Title - Sujet Revitalisation Havre-Kégaska	
Solicitation No. - N° de l'invitation F3731-160062/A	Amendment No. - N° modif. 004
Client Reference No. - N° de référence du client F3731-160062	Date 2016-08-09
GETS Reference No. - N° de référence de SEAG PW-\$QCL-018-16817	
File No. - N° de dossier QCL-6-39095 (018)	CCC No./N° CCC - FMS No./N° VME
Solicitation Closes - L'invitation prend fin at - à 02:00 PM on - le 2016-08-24	Time Zone Fuseau horaire Heure Avancée de l'Est HAE
F.O.B. - F.A.B. Plant-Usine: <input type="checkbox"/> Destination: <input checked="" type="checkbox"/> Other-Autre: <input type="checkbox"/>	
Address Enquiries to: - Adresser toutes questions à: Piras, Gabriel	Buyer Id - Id de l'acheteur qcl018
Telephone No. - N° de téléphone (418) 649-2870 ()	FAX No. - N° de FAX (418) 648-2209
Destination - of Goods, Services, and Construction: Destination - des biens, services et construction:

**TITLE: KEGASKA, LOWER NORTH SHORE – HARBOUR REVITALIZATION
AMENDMENT 004**

Included in the present amendment:

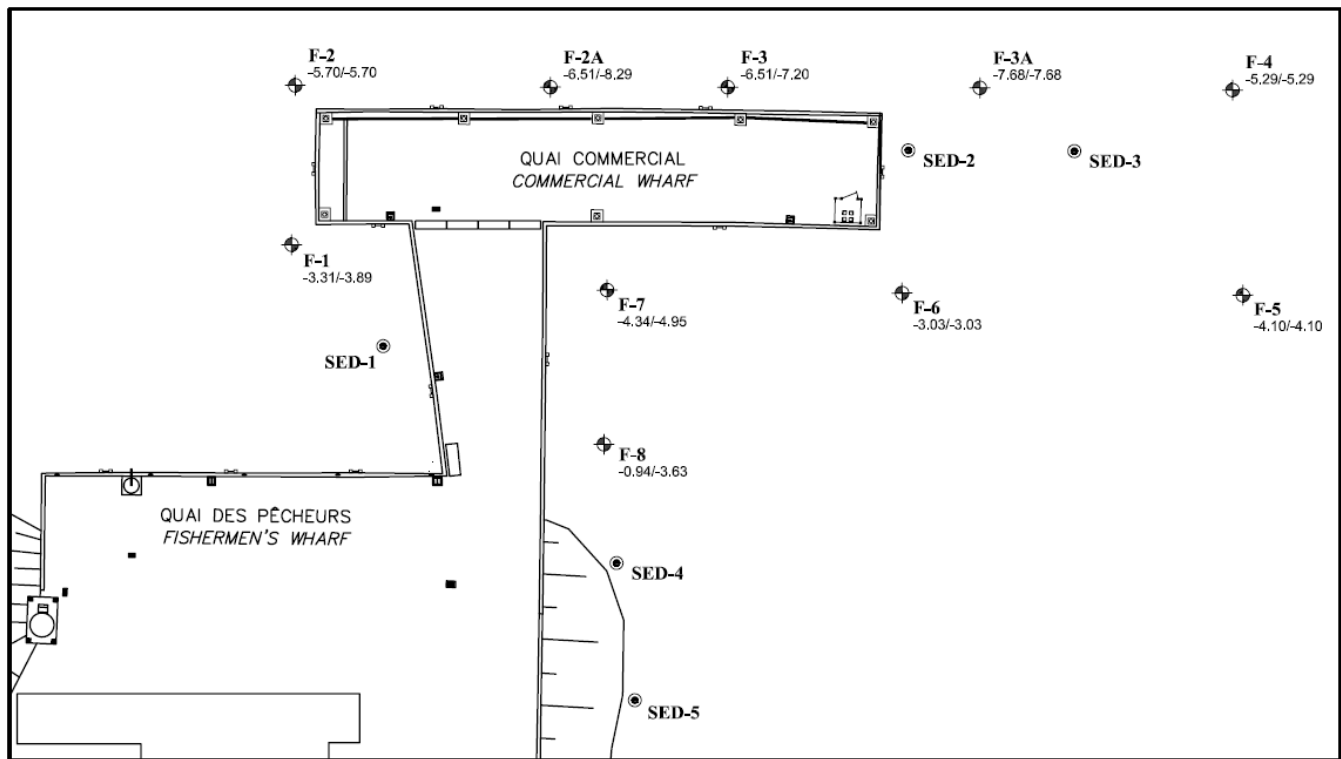
Question 10

Could you provide Annex 6 of the geotechnical study (drill location map)?

Answer : Please see the following drawing for the boreholes locations.
